## CALIFORNIA COASTAL COMMISSION

**SUBJECT:** Revised Findings for Major Amendment (2-97) to the University of California Santa Barbara Certified Long Range Development Plan for Public Hearing and Commission Action at the September 10, 1998 Commission Meeting in Eureka.

**COMMISSION ACTION:** Denial as Submitted and Approval if Modified as Suggested.

EXHIBIT 3a  
 UCSB LRDPA 2-97  
 Site Plan-Lagoon Barrier

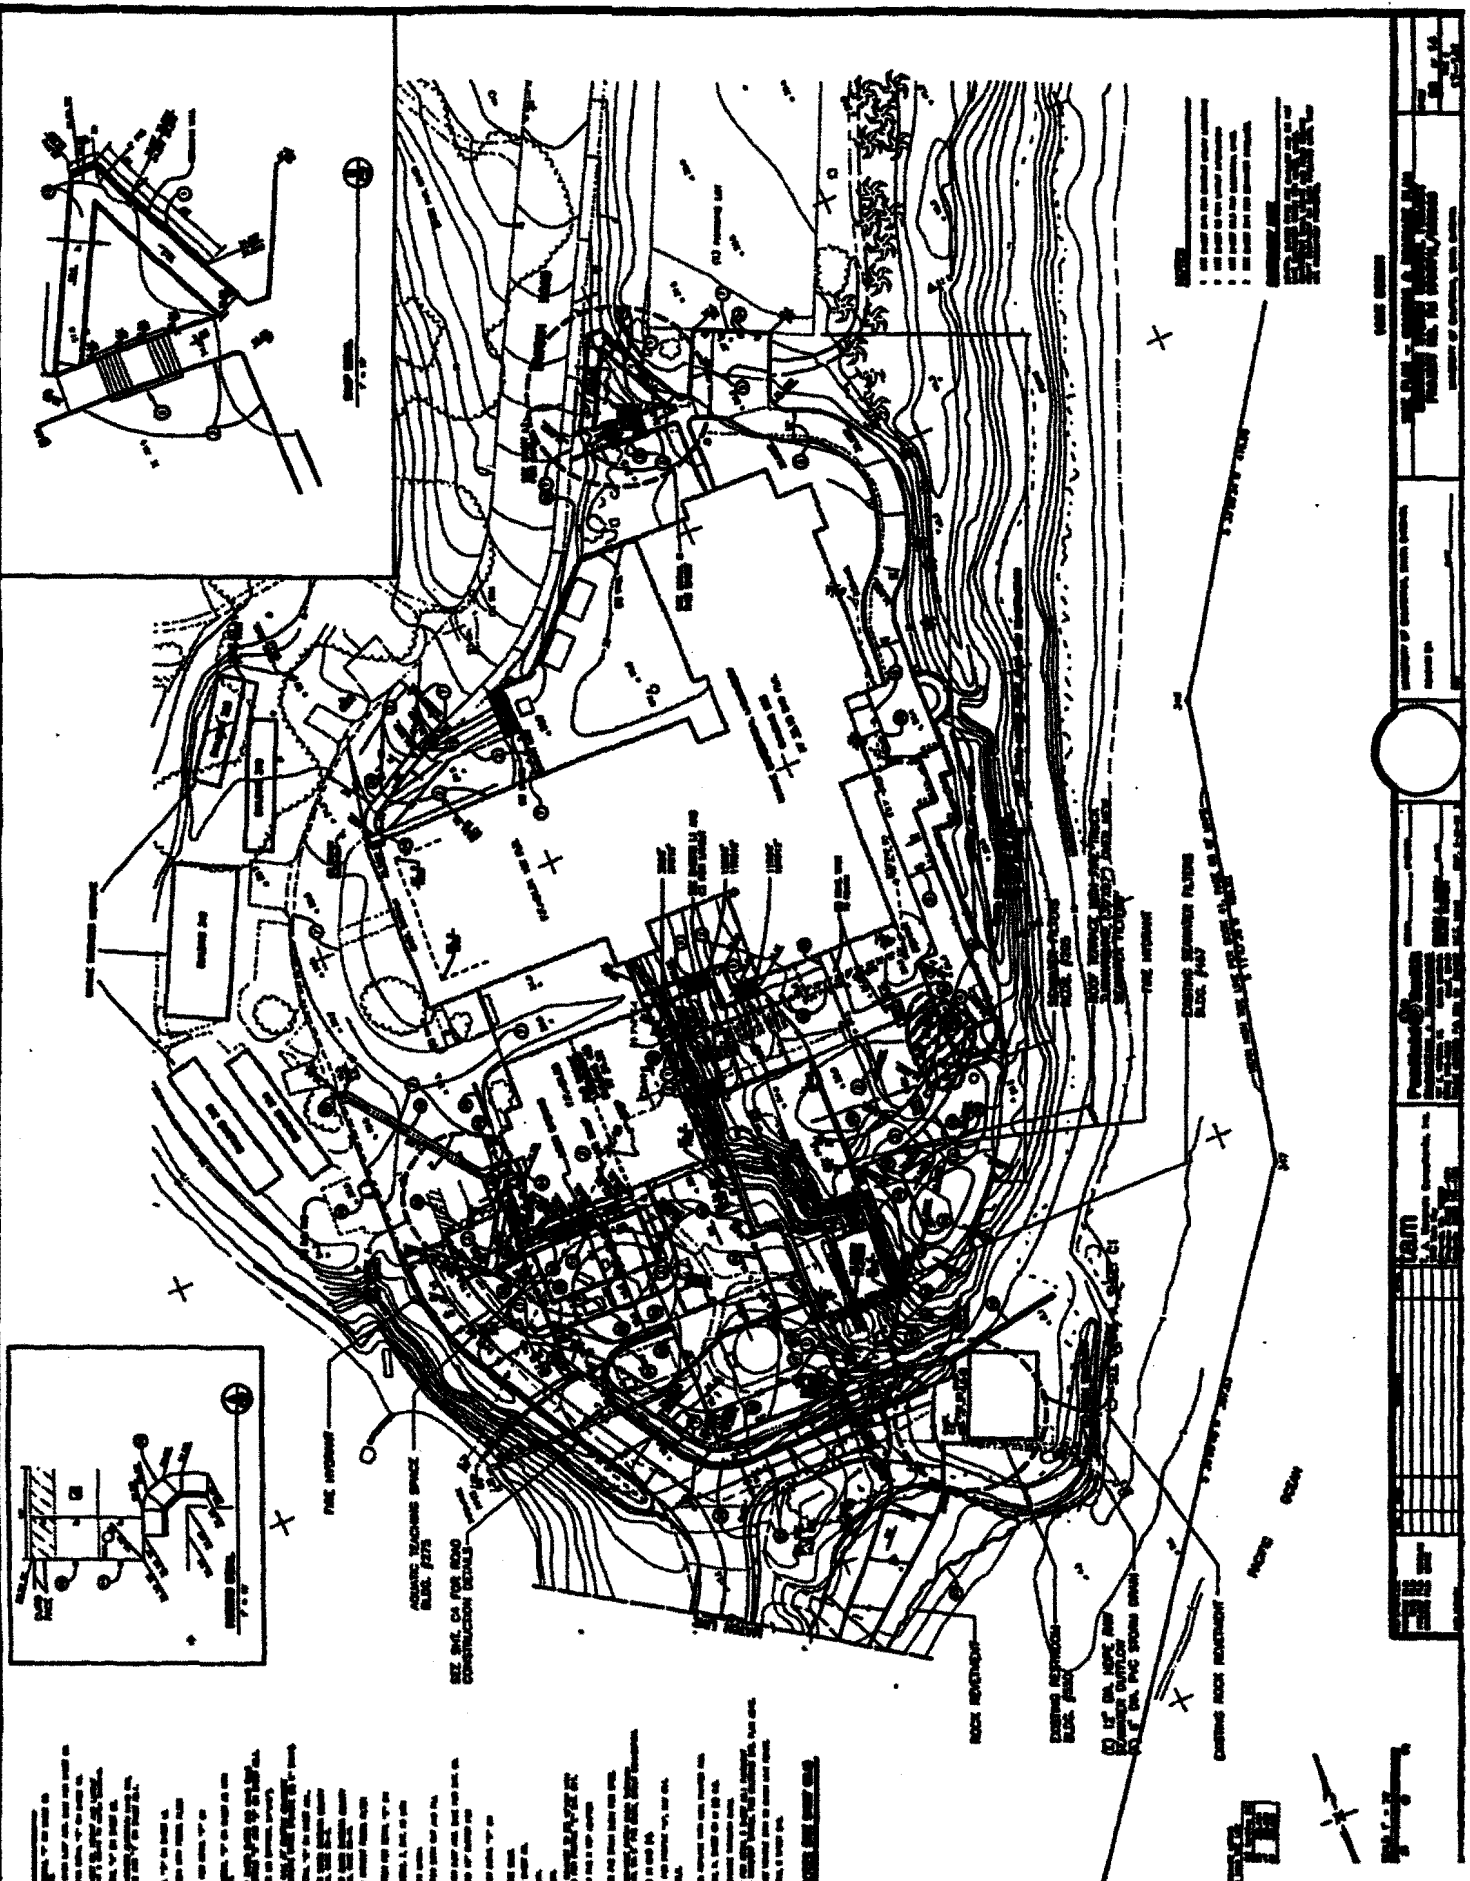
The University of California Santa Barbara is requesting an amendment to its Long Range Development Plan (LRDP). The amendment consists of four components: (1) expansion of the existing seawater renewal system; (2) adoption of the Lagoon Management Plan; (3) change in the proposed location of a public coastal access trail; and (4) added provisions to allow for improvements to the existing eastern lagoon barrier which will include 700 cu. yds. of grading, pavement of an existing access road across the barrier, construction of emergency vehicle turnaround, and the construction of an approximately 460 linear ft. long, 15-32 ft. wide, rock revetment core/dune.

A cobblestone revetment to maintain the lagoon barrier and prevent breaching is identified for future development in the 1990 LRDP. The University is now proposing to construct a more substantial rock revetment core/dune which will occupy 25-50 percent of the public sandy beach to protect the existing/expanded seawater renewal system pumphouse, intake lines and lagoon barrier. However, regardless of the type of shoreline protection device to be used, the LRDP also specifically states that any future revetment would be subject to Coastal Commission review. In addition, the State Lands Commission has determined that the proposed revetment will be located on sandy beach seaward of the mean high tide and will therefore be subject to a lease agreement between the University and the State Lands Commission. Although the University has a certified Long Range Development Plan, the proposed rock revetment core/dune, pumphouse, and intake lines are located within the original permit

Other improvements to the existing lagoon barrier would include the placement of approximately 700 cu. yds. of fill to raise the height of the barrier from approximately 8 ft. mean sea level (MSL) to approximately 11 ft. MSL. In addition, the University proposes to pave the access road across the barrier and construct a turnaround at the terminus of the access road at Lagoon Island. The Commission notes that the pavement of an access road atop the proposed 700 cu. yds. of fill would constitute the construction of a new, or reconfigured, road across the lagoon barrier. Sand elevation is approximately 5 ft. MSL at the lagoon barrier. As the lagoon barrier now exists, beachgoers may easily access the sandy beach from any point along the approximately 400 ft. long barrier road with only an approximate change in elevation between the road and the beach of 3 ft. As such, the placement of fill to increase the height of the barrier and reconfiguration of the existing access road, including the construction of the turnaround, will raise concerns under the Coastal Act policies regarding impacts to public access.

The proposed amendment is inconsistent with the Coastal Act. Section 30235 of the Coastal Act allows for the construction of a shoreline protection device when necessary to protect existing development and coastal dependent uses only when designed to eliminate or mitigate adverse impacts to the shoreline sand supply. However, under Section 30235 of the Coastal Act, the proposed rock revetment core/dune can not be considered "necessary" if a feasible alternative which would result in fewer adverse impacts to coastal resources exists. In this case, there may be feasible shoreline protective alternatives which could result in less adverse impacts to the shoreline sand supply and public access than the proposed rock revetment core/dune and these possible alternatives have not been adequately addressed in the Environmental Impact Report (EIR) or other information submitted for the proposed amendment. Therefore, the Commission can not find that the rock revetment core/dune component of the proposed amendment is consistent with the Coastal Act. Further, the policies within the LRDP are inadequate to ensure that any adverse impacts to public access, environmentally sensitive habitat resources, and shoreline sand supply which may result from the proposed amendment would be adequately mitigated.

Therefore, the Commission can not find that the rock revetment core/dune component of the proposed amendment is consistent with §30235 and §30253 of the Coastal Act. Modification one (1) is suggested in order to ensure that the proposed textual amendment of the LRDP does not provide for the construction of a rock revetment core/dune before all feasible alternatives which would result in less adverse impacts to shoreline sand supply, public access, and habitat resources have been considered. Modification four (4) is suggested to ensure that all references (text and figures) within the LRDP which refer to a revetment to protect the lagoon barrier and pump house are consistent with the language contained in modification one (1). Modification Two (2) is suggested in order to ensure that the policies contained within the LRDP are sufficient to provide for the elimination or mitigation of adverse impacts to shoreline sand supply and public access from the use of shoreline protection devices. The Lagoon Management Plan which the University proposes to incorporate into the LRDP makes extensive references to the placement of a rock revetment to protect the lagoon barrier and seawater renewal system and, therefore, is not consistent with the LRDP or §30235 and §30253 of the Coastal Act. In order to ensure that the proposed amendment is consistent with §30235 and §30253 of the Coastal Act, and to allow further review by the Commission of the Lagoon Management Plan through a separate amendment application, Modification Three (3) is suggested to ensure that the proposed Lagoon Management Plan is deleted in its entirety from this amendment to the UCSB Long Range Development Plan. Modification Five (5) is suggested to ensure that all references (text and figures) in this amendment to the Long Range Development Plan which would allow for improvements to the lagoon barrier which are integrally related to the construction of the proposed rock revetment core dune, including the placement of fill resulting in an increase in the height of the barrier, pavement of the existing access road, and the construction of a vehicle turnaround, shall be deleted. Therefore, the Commission finds that the proposed amendment to the LRDP, as modified, is consistent with the Chapter 3 policies of the Coastal Act.

All references to the use or construction of a revetment shall be replaced with the following language (consistent with modification one):

*Shoreline protection and enhancement programs that minimize adverse impacts to shoreline sand supply, public access and the habitat value of the beach ESHA, such as dune nourishment and/or beach replenishment, shall be considered as potential form(s) of protection for the lagoon barrier... If shoreline protection is permitted, it shall not degrade the visual quality of the area, or become a safety hazard... Shoreline protection shall be designed to: (1) protect, and to maximum extent feasible enhance, the environmentally sensitive habitat areas as designated by the LRDP (Figure 27), (2) protect the lagoon barrier, and (3) minimize alteration of natural shoreline processes and maintain coastal access along dry sand area.*

All figures within the LRDP shall be revised or replaced consistent with this modification.
